Received by MCD.S1/11/2021 3:04:14 PM U.S. Department of the Interior BUREAU OF LAND MANAGEMENT	Sundry Print Repor		
Well Name: DOMINATOR 25 FEDERAL COM	Well Location: T25S / R33E / SEC 25 / SWSE / 32.095027 / -103.523824	County or Parish/State: LEA / NM	
Well Number: 605H	Type of Well: OIL WELL	Allottee or Tribe Name:	
Lease Number: NMNM121958	Unit or CA Name: DOMINATOR 25 FED COM WELLS-WLF	Unit or CA Number: NMNM138694	
US Well Number: 300254474200S1	Well Status: Producing Oil Well	Operator: COG OPERATING LLC

### **Notice of Intent**

**Procedure Description:** COG Operating LLC respectfully requests temporary abandonment of the Dominator 25 Federal Com #605H. Three additional wells will be drilled on the same pad as the Dominator 25 Federal Com #605H so it will need to have production tubing pulled and the wellhead reduced to ground level in order to safely execute the drilling and completion of the new wells on this pad. Temporary abandonment operations are expected to begin October 7th,2021. This well is expected to be put back on production in the fourth quarter of 2022. 1.) MIRU pulling unit, ND tree, NU BOP. 2.) POOH w/ production tubing. 3.) RIH w/ CIBP and set +/-75ft ab

See attachments for current wellbore diagram, proposed wellbore diagram, and perforation depths.

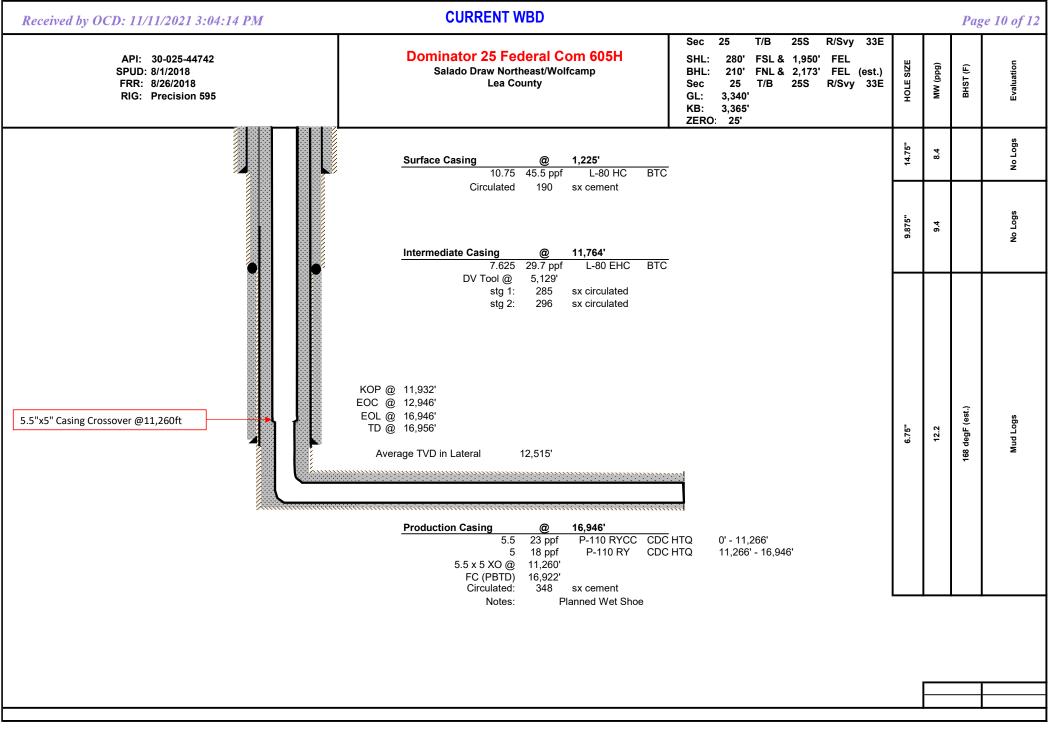
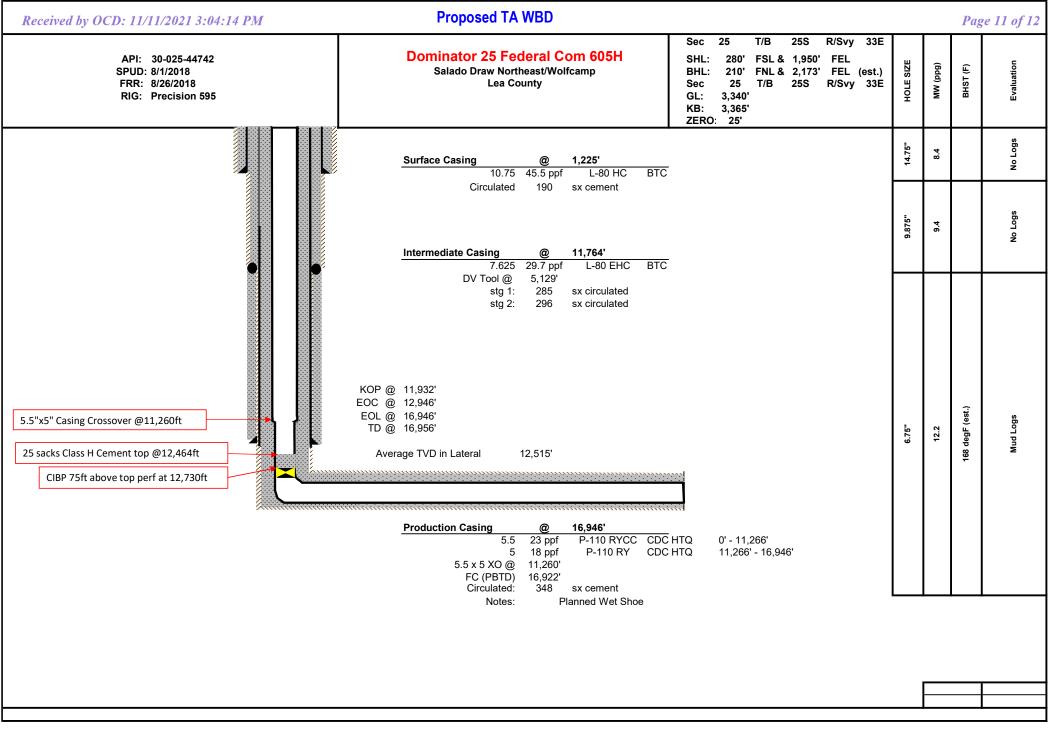
- 1.) MIRU pulling unit, ND tree, NU BOP.
- 2.) POOH w/ production tubing.
- 3.) RIH w/ CIBP and set +/-75ft above top perforation at 12,730ft.
- 4.) Spot 25 sacks of Class H cement on top of CIBP.
- 5.) Tag top of cement and displace wellbore with corrosion inhibited fluid.
- 6.) Test casing to 500psi for 30min and document with test pressure recording device.
- 7.) ND BOP and install TA cap.
- 8.) RDMO.

- 1.) MIRU pulling unit, ND tree, NU BOP.
- 2.) POOH w/ production tubing.
- 3.) RIH w/ CIBP and set +/-50ft above top perforation at 12,730ft.
- 4.) Spot 25 sacks of Class H cement on top of CIBP. WOC AND TAG
- 5.) Tag top of cement and displace wellbore with corrosion inhibited fluid.
- 6.) Test casing to 500psi for 30min and document with test pressure recording device.
- 7.) ND BOP and install TA cap.
- 8.) RDMO.
